REMARKS/ARGUMENTS

Appl. No. 10/037,278
Amdt. dated June 16, 2005
Reply to Office Action of March 16, 2005

Amendments to the Drawings:

FIG. 1B

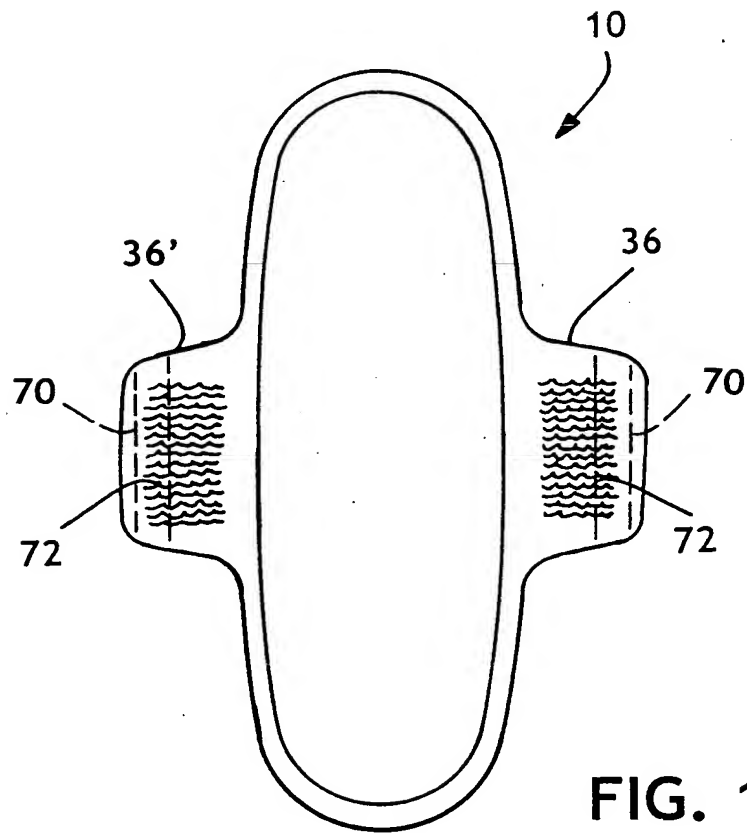
The Examiner also states in the Office Action that the submitted drawings did not include corrections of all the objections to the drawings, in particular to Figures 1B and 1C. Applicants are submitting herewith a new sheet of drawings including Figures 1B and 1C. Applicants' undersigned representative, based on Applicants file, was under the impression that formal drawings for Figures 1B and 1C were previously filed. However, upon reviewing the Private Pair and the file image, it was discovered that formal drawings for Figures 1B and 1C are not part of the Patent Office's electronic file.

On page 3 of the Office Action, the Examiner repeats previous objections to the drawings. The drawings submitted in the July 28, 2004 Amendment, entered per the request of the RCE filed on October 5, 2004, with the possible exception of Figures 1B and 1C, address all of these objections. The Examiner's attention is directed to the comments made in the July 28, 2004 amendment, which the Applicant's hereby incorporate by reference for the sake of brevity. Again, Applicants respectfully request that the previous drawings be entered by the Examiner, in addition to the attached sheet of drawings including Figures 1B and 1C, since they materially reduce the numerous issues raised by Examiner in this application.

The attached sheet of drawings includes changes to Fig. 1B and 1C. This sheet, which includes Fig. 1B and 1C, replaces the original sheets including Fig. 1B and 1C.
